Reddam House - New Boarding House

Planning Response 03- App. 243228

25th March 2024

Planning Application Comments Response

Drawing 0363-BDL-XX-XX-DR-L-0001-P02, updated detailed plan extract, additional information.

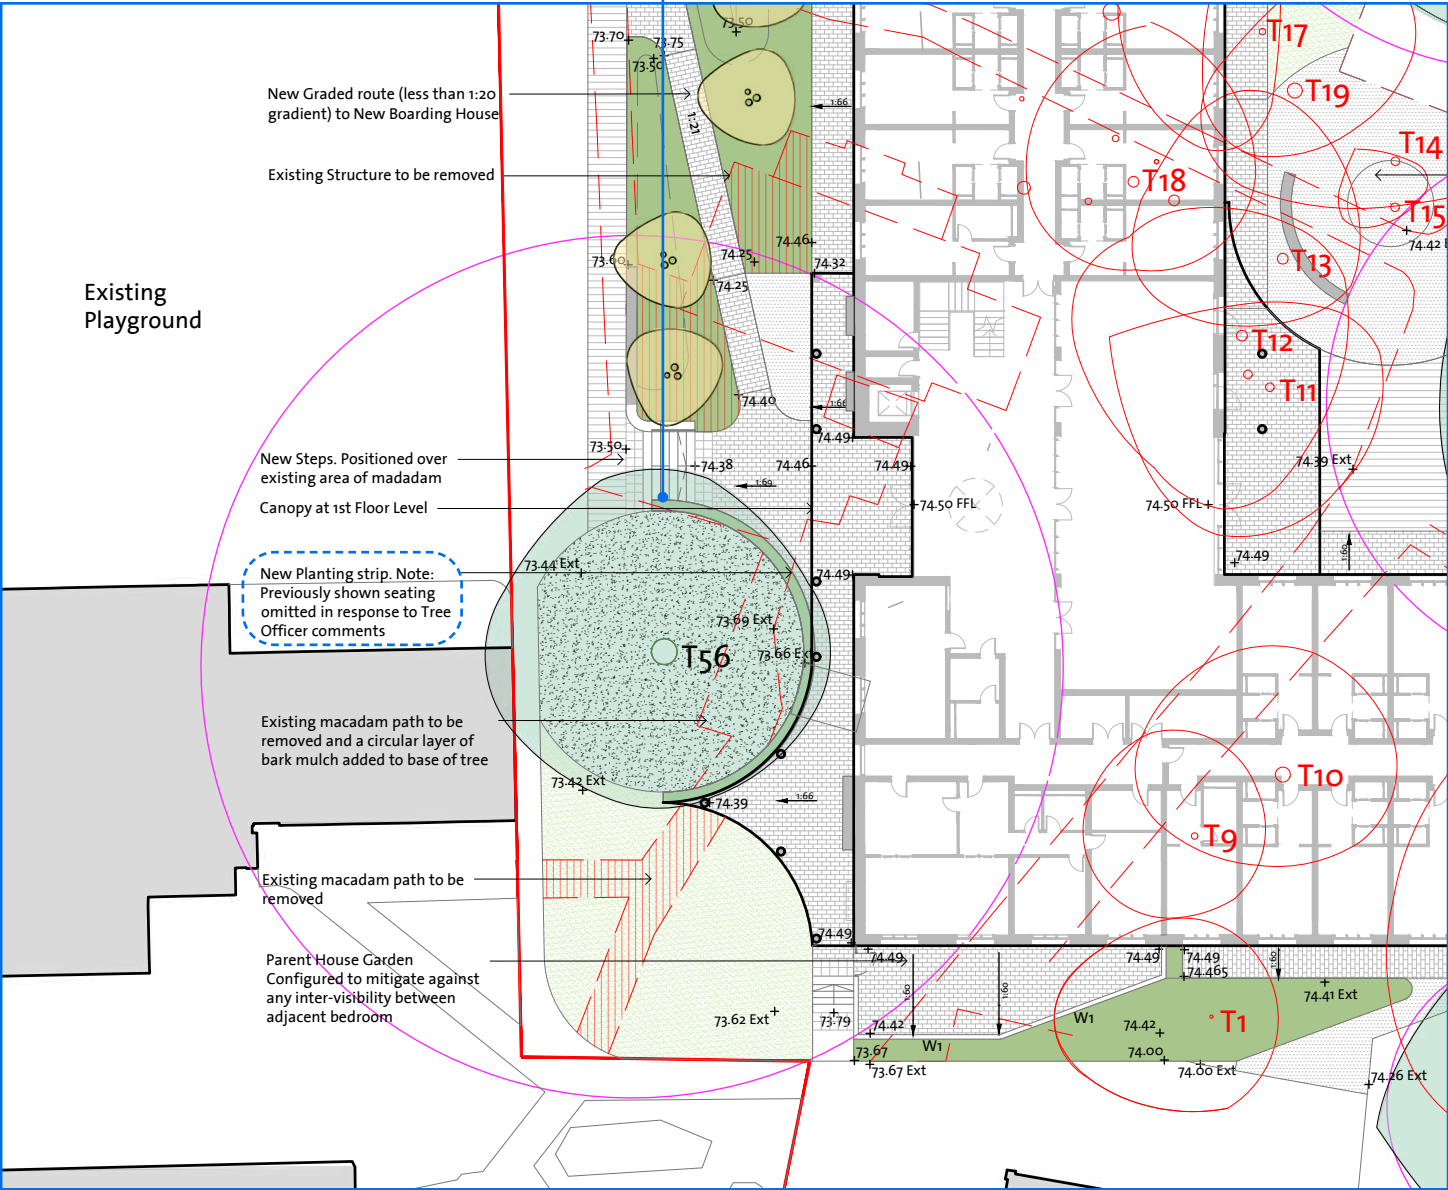
2.5 Structures (such as seating) need to be on the outer edge of the RPA facing outwards. Proposals for ameliorating the RPA need to be included, that will also naturally form part of the soft landscape design.

We need to understand how the RPA will be protected within the landscape design and it needs to be shown how the existing landscape can be improved upon across the whole of the area within the red line boundary and the additional area for the RPA.

The visual focus of the site /seating area shown on page 25 of the response report centred around T56 is not sustainable and is development within the Veteran tree Buffer Zone which needs to be avoided.

2.5 Design reviewed, seating substituted with a planter to avoid people congregating in the Cedar Garden within the Veteran tree Buffer Zone as per officer comments.

- Drawing reference 0363-BDL-XX-XX-DR-L-0001-P02 Landscape Plan. This drawing shows the new planting strip after the removal of the seating facing the tree.

Seating substituted with planter, to create a protection to the tree buffer zone.
